Safety of Gas Transmission and Gathering Pipelines

Docket: PHMSA - 2011 – 0023

Gas Pipeline Advisory Committee Meeting

March 2, 2018

Fig. 4 Timing for Scheduled Responses: Time-Dependent Threats, Prescriptive Integrity Management Plan

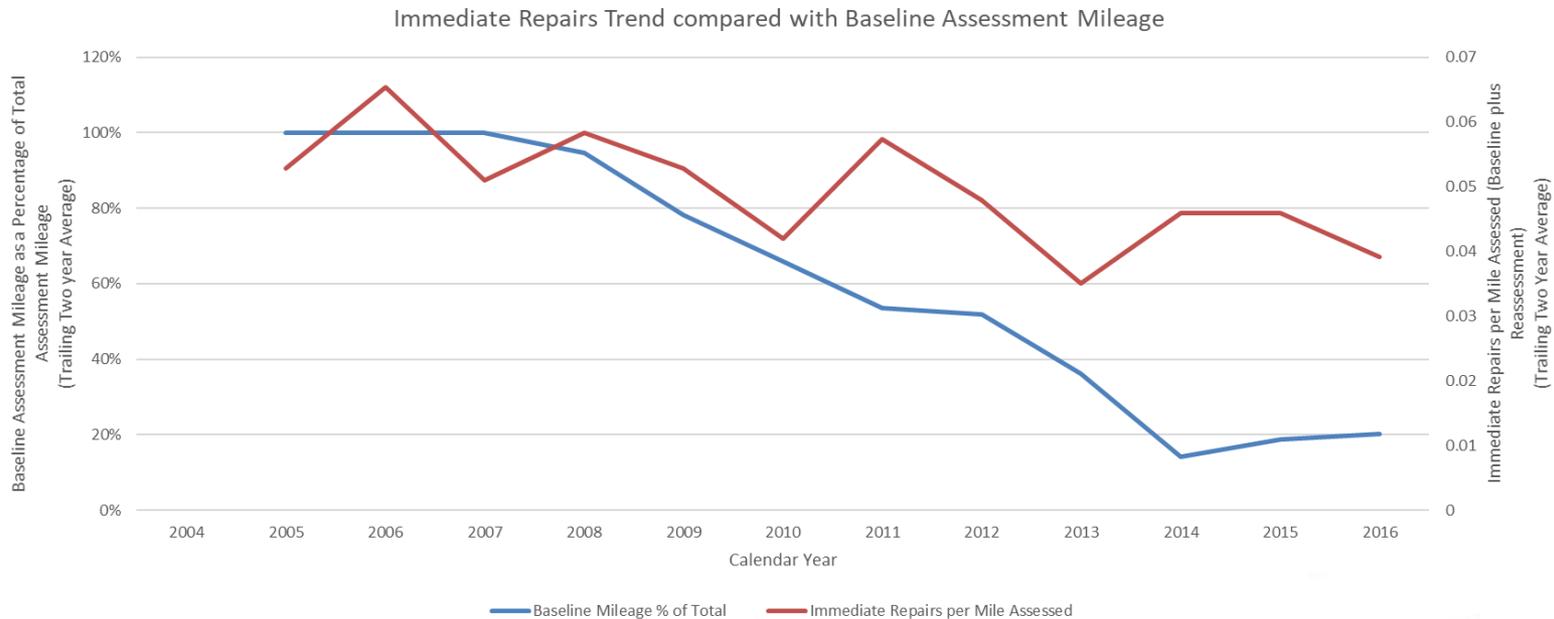
- ASME B31.8S should be applied for remediation based decisions. However, PHMSA proposes contradictory approaches by also requiring depth based criteria (% of nominal wall thickness) in subsequent proposed revisions to the regulation. PHMSA should only reference ASME B31.8S, which is considered the best accepted practice.
- **PHMSA:** The use of B31G/RSTRENG is not applicable to metal loss >80% wt. The use of B31G/RSTRENG with B31.8S (Fig. 4.) does not assure that this limitation is observed. PHMSA explicitly added 80% wall loss criterion to assure that all such defects are repaired immediately. PHMSA also added criteria for cracking. The current repair criteria are silent on cracks and crack-like defects.

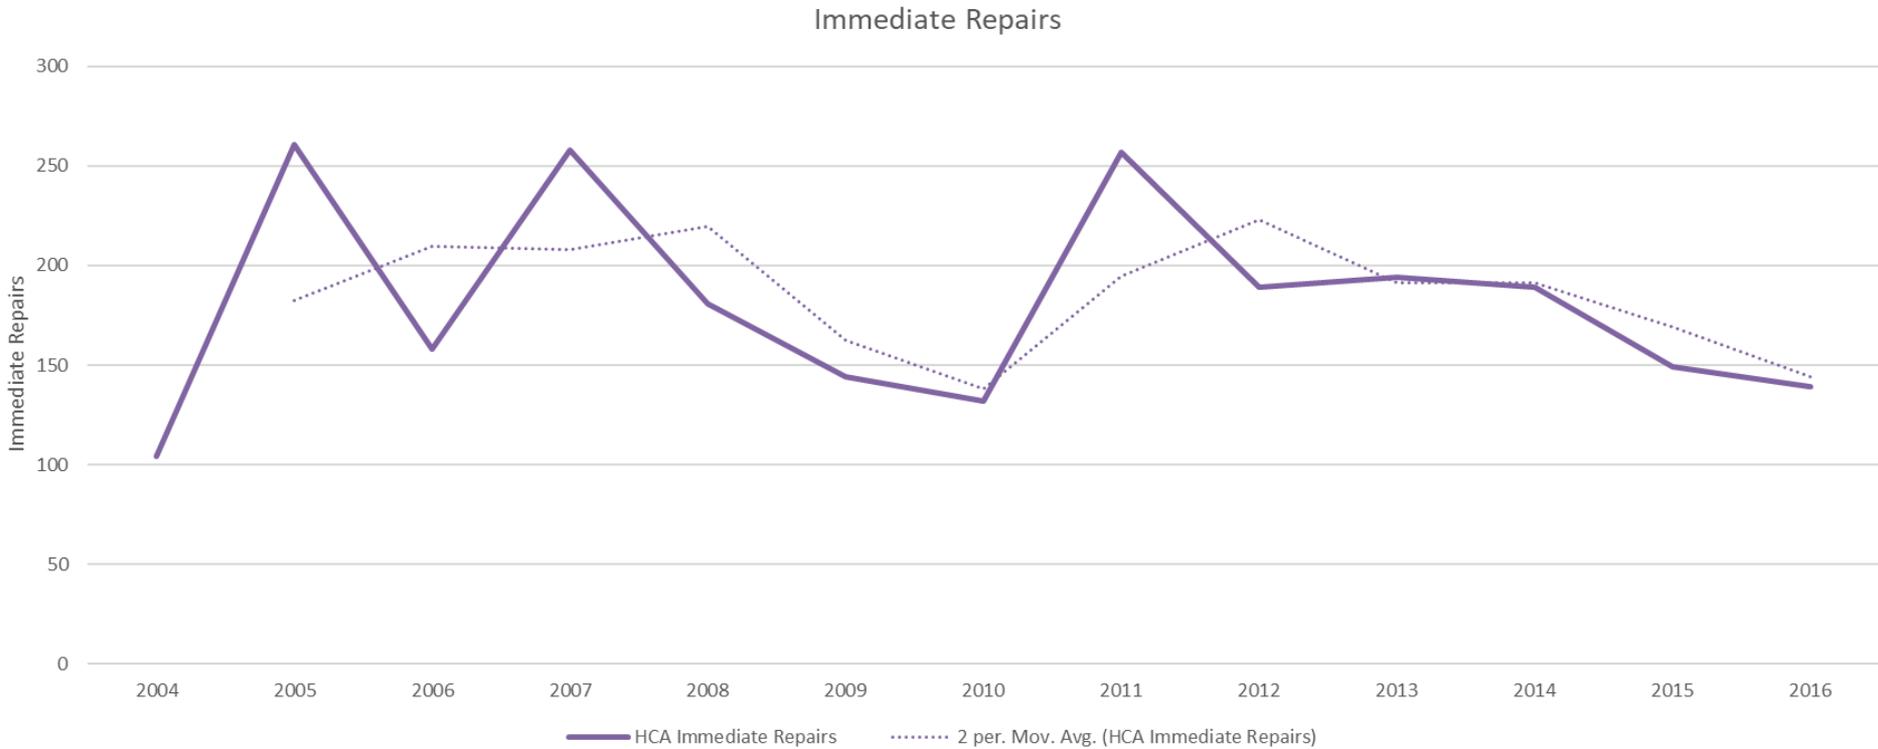
- **PHMSA** has also noted that the trend in immediate repairs has not decreased commensurate with the conclusion of the baseline assessment effort at the end of 2012.
